SYS-01

ILLINOIS DEPARTMENT OF TRANSPORTATION
 F.A.I. 94/90 (DAN RYAN EXPRESSWAY)
 31st STREET to I-57

DYNAMIC MESSAGE SIGN SUBSYSTEM

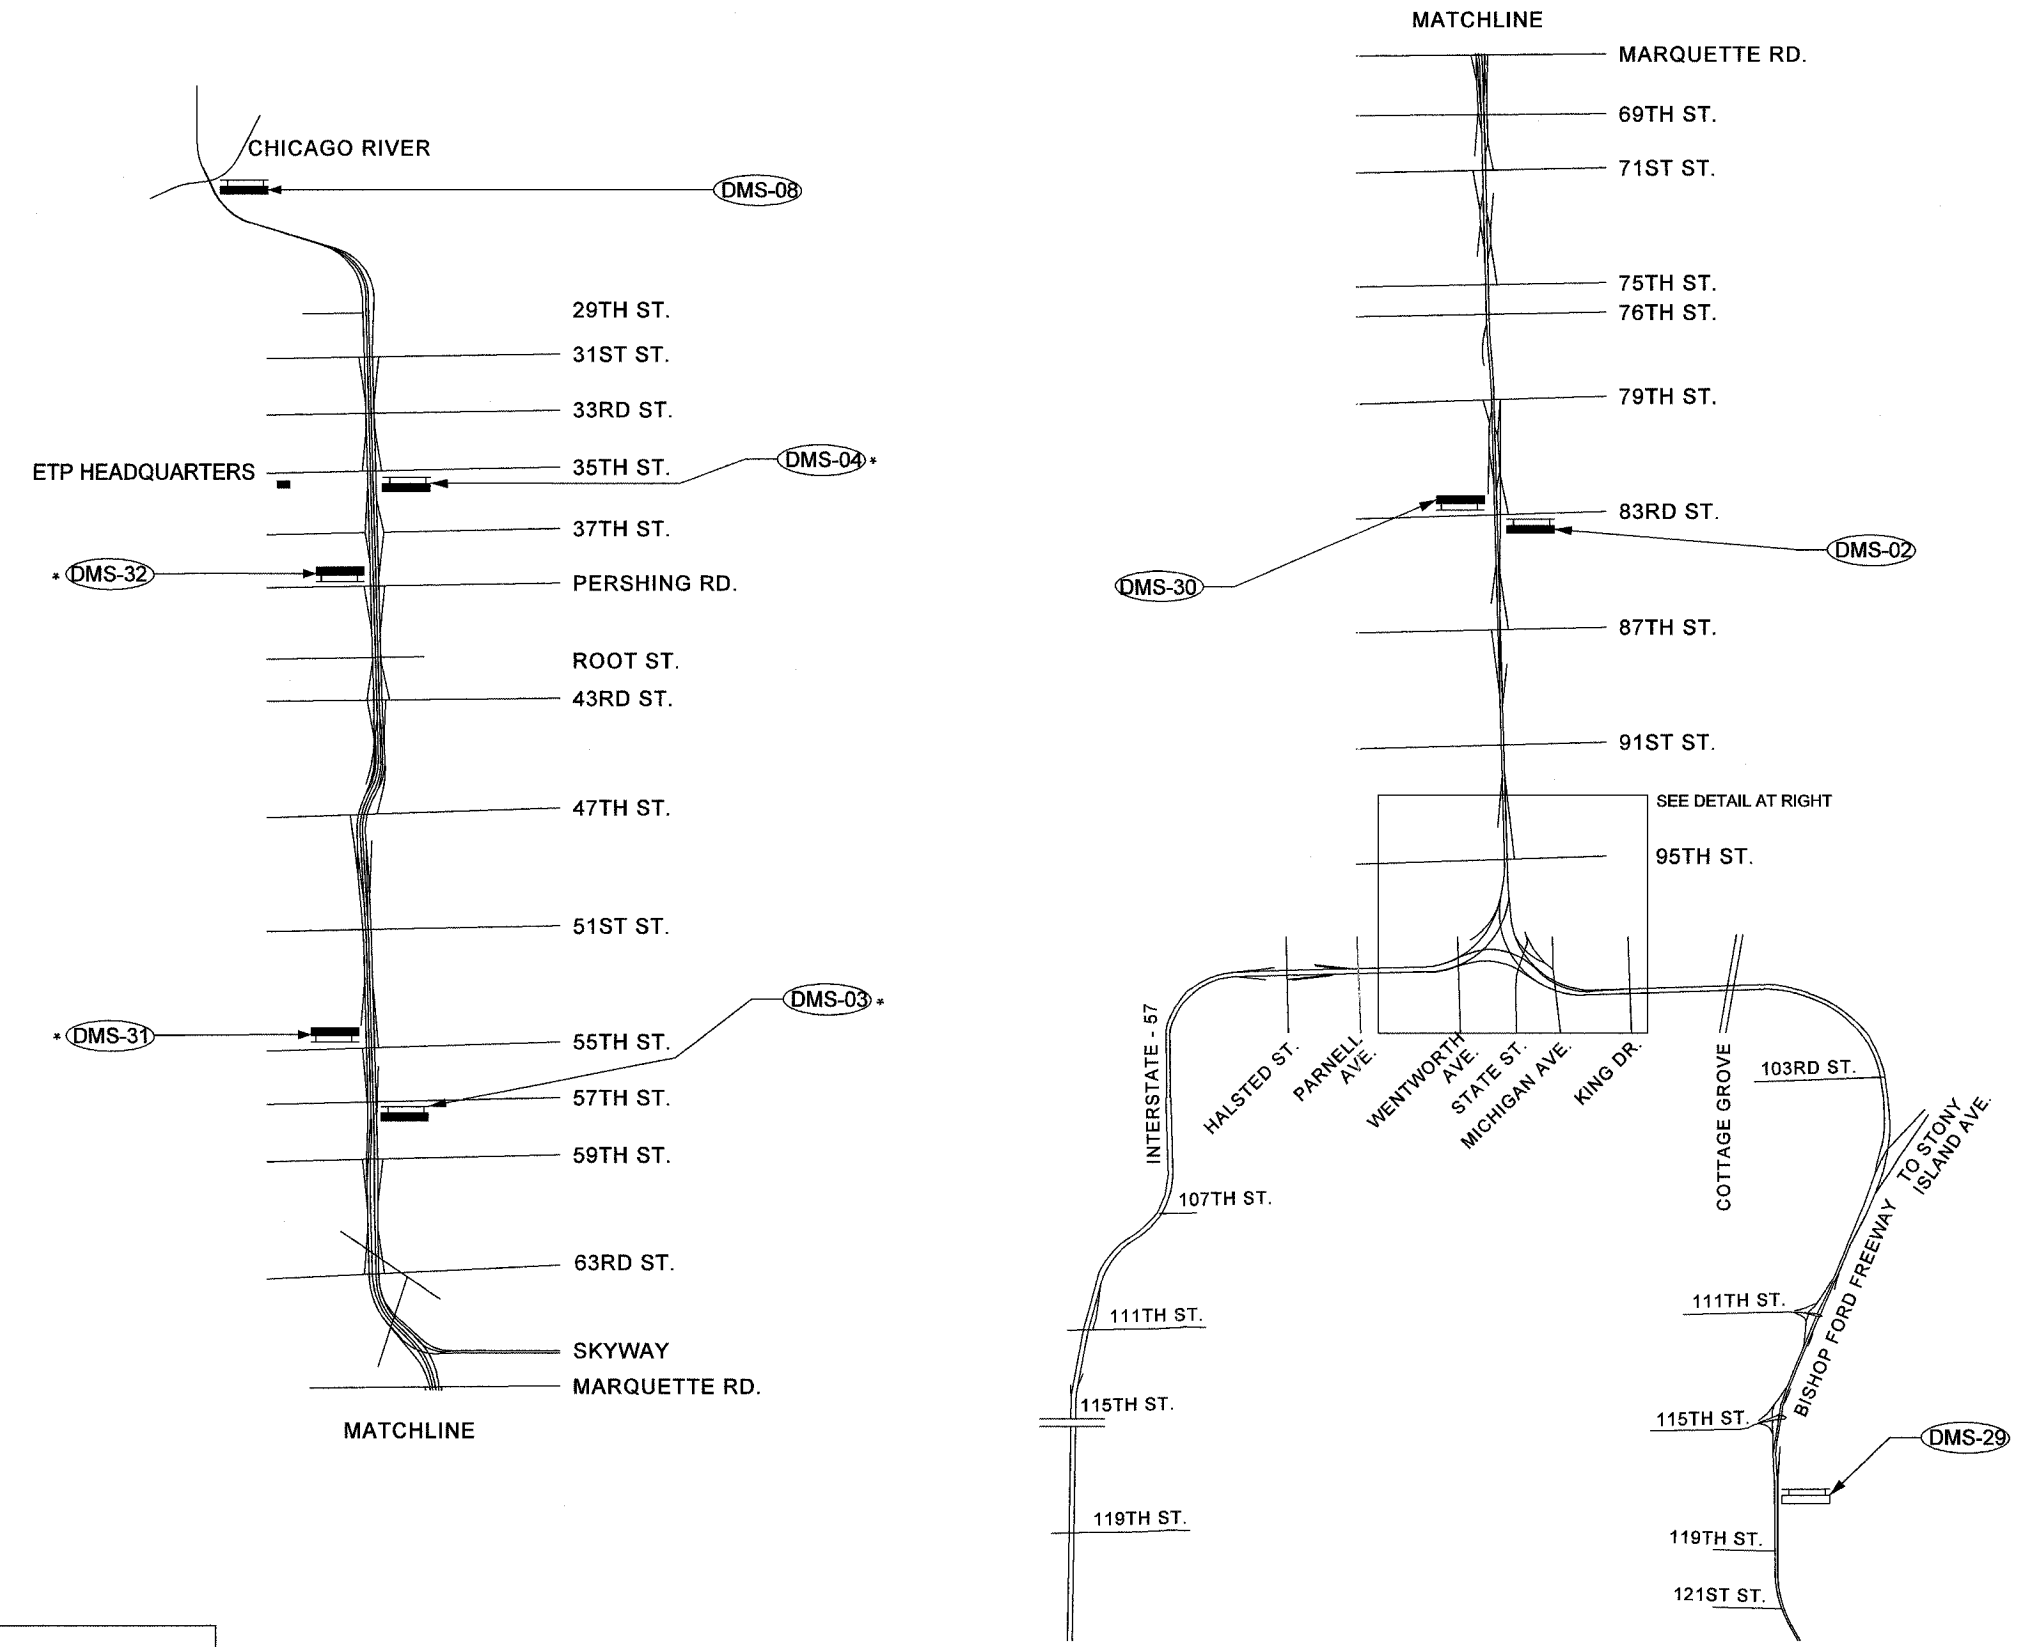
* DMS-03, DMS-31, DMS-32, DMS-04 ARE SHOWN IN THESE PLANS AS INSTALLED ON BUTTERFLY TRUSSES. SITE PLANS FOR THESE DRAWINGS WILL BE MODIFIED BY ADDENDUM TO SHOW TWO SIGNS AT EACH OF THESE LOCATIONS INSTALLED ON SEPARATE FULL SPAN TRUSSES. ONE SIGN WILL BE POSITIONED OVER THE EXPRESS LANES AND ONE OVER THE LOCAL LANES AT EACH LOCATION.
